ECK 8TH ADDITION  
WICHITA, SEDGWICK COUNTY, KANSAS

RE: SUB 2001-38 -- Final Plat of Eck Eighth Addition

RE: SUB 2001-38 -- Final Plat of Eck Eighth Addition

**CASE NUMBER:** SUB 2001-38-- ECK 8TH ADDITION

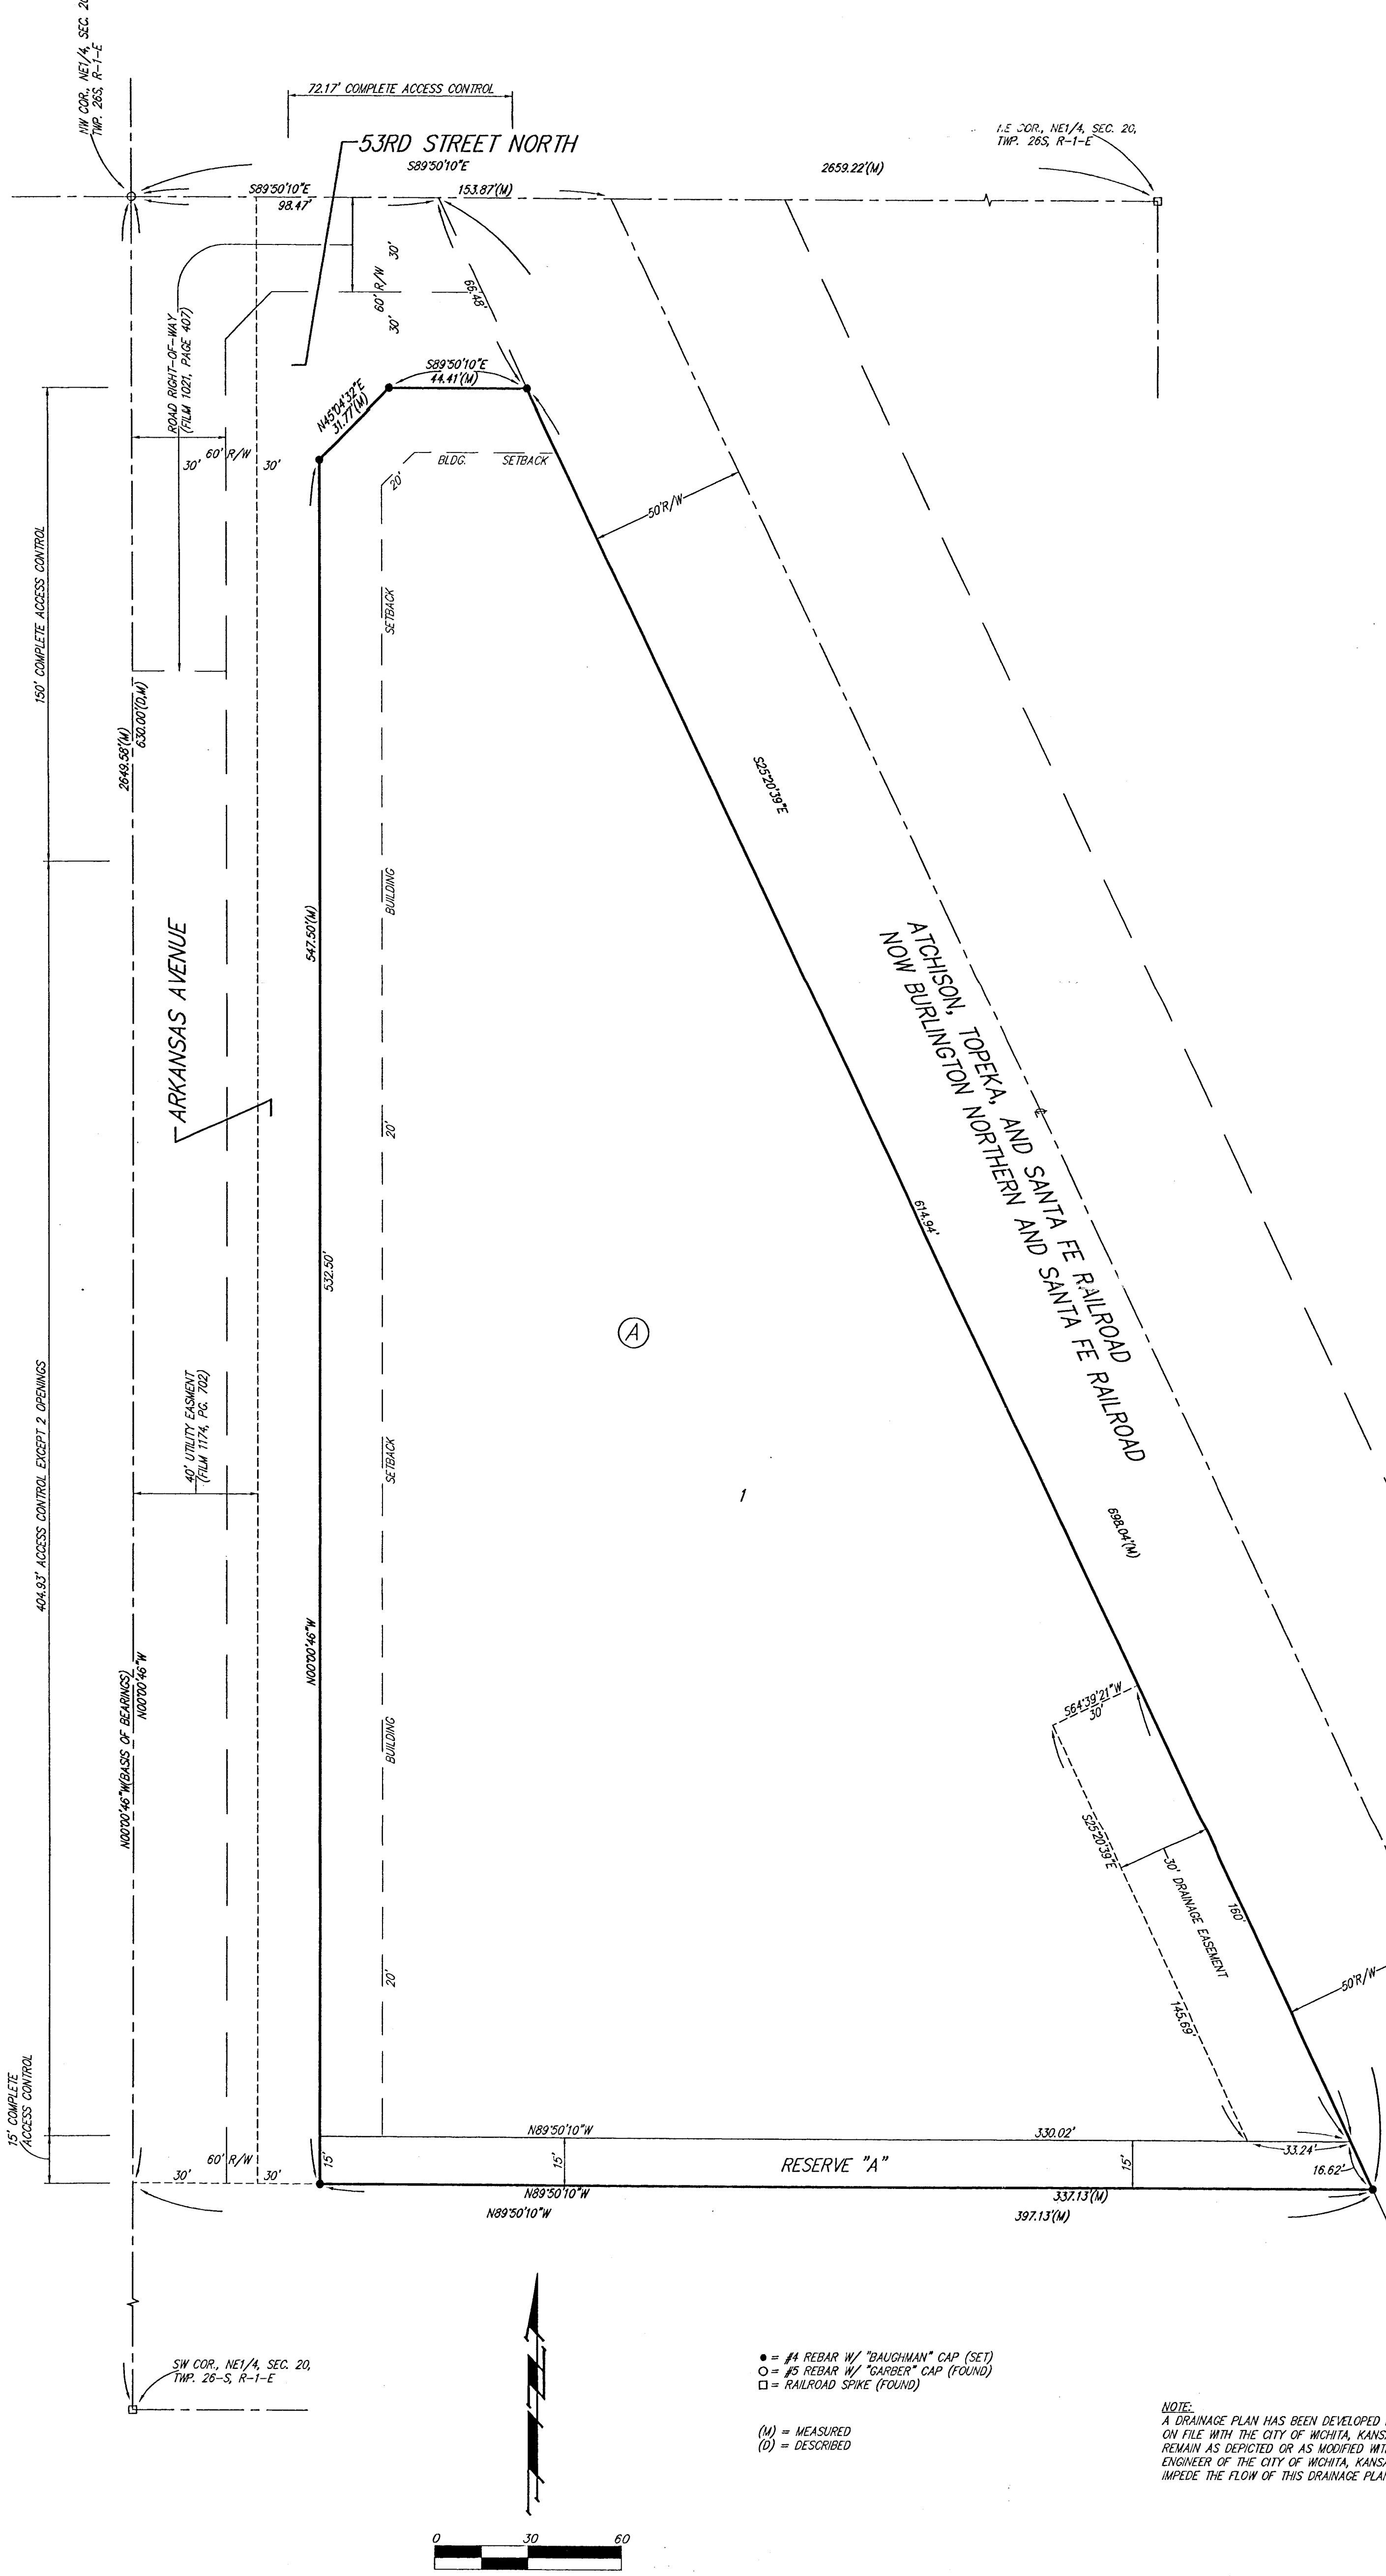
- C. City Engineering needs to comment on the status of the applicant's drainage plan. The drainage plan indicates a need for off-site detention. An off-site easement for detention will be needed along with a drainage guarantee.

- F. The plat proposes two access openings along Arkansas and complete access control along 53rd St. North. In accordance with the Subdivision regulations, any access openings located within 250 feet of the intersection of Arkansas and 53rd St. North (measured from curb) are limited to right-turns only, and shall be referenced on the face of the plat; or a guarantee provided for the future construction of a raised medial.

- G. Traffic Engineering needs to comment on the need for additional right-of-way. The Subdivision Regulations require 75 feet of half-street right-of-way at arterial intersections. Traffic Engineering has required the right-of-way be increased to a 60-ft right-of-way with a corner clip.

- K. The platting text shall include language that a drainage plan has been developed for the plat and that all drainage easements, rights-of-way, or reserves shall remain at established grades or as modified with the approval of the applicable City or County Engineer, and unobstructed to allow for the conveyance of stormwater.

- S. The representatives from the utility companies should be prepared to comment on the need for any additional utility easements to be platted on this property. **Southwestern Bell and KGE have requested revised language on the plat regarding utility easements.**
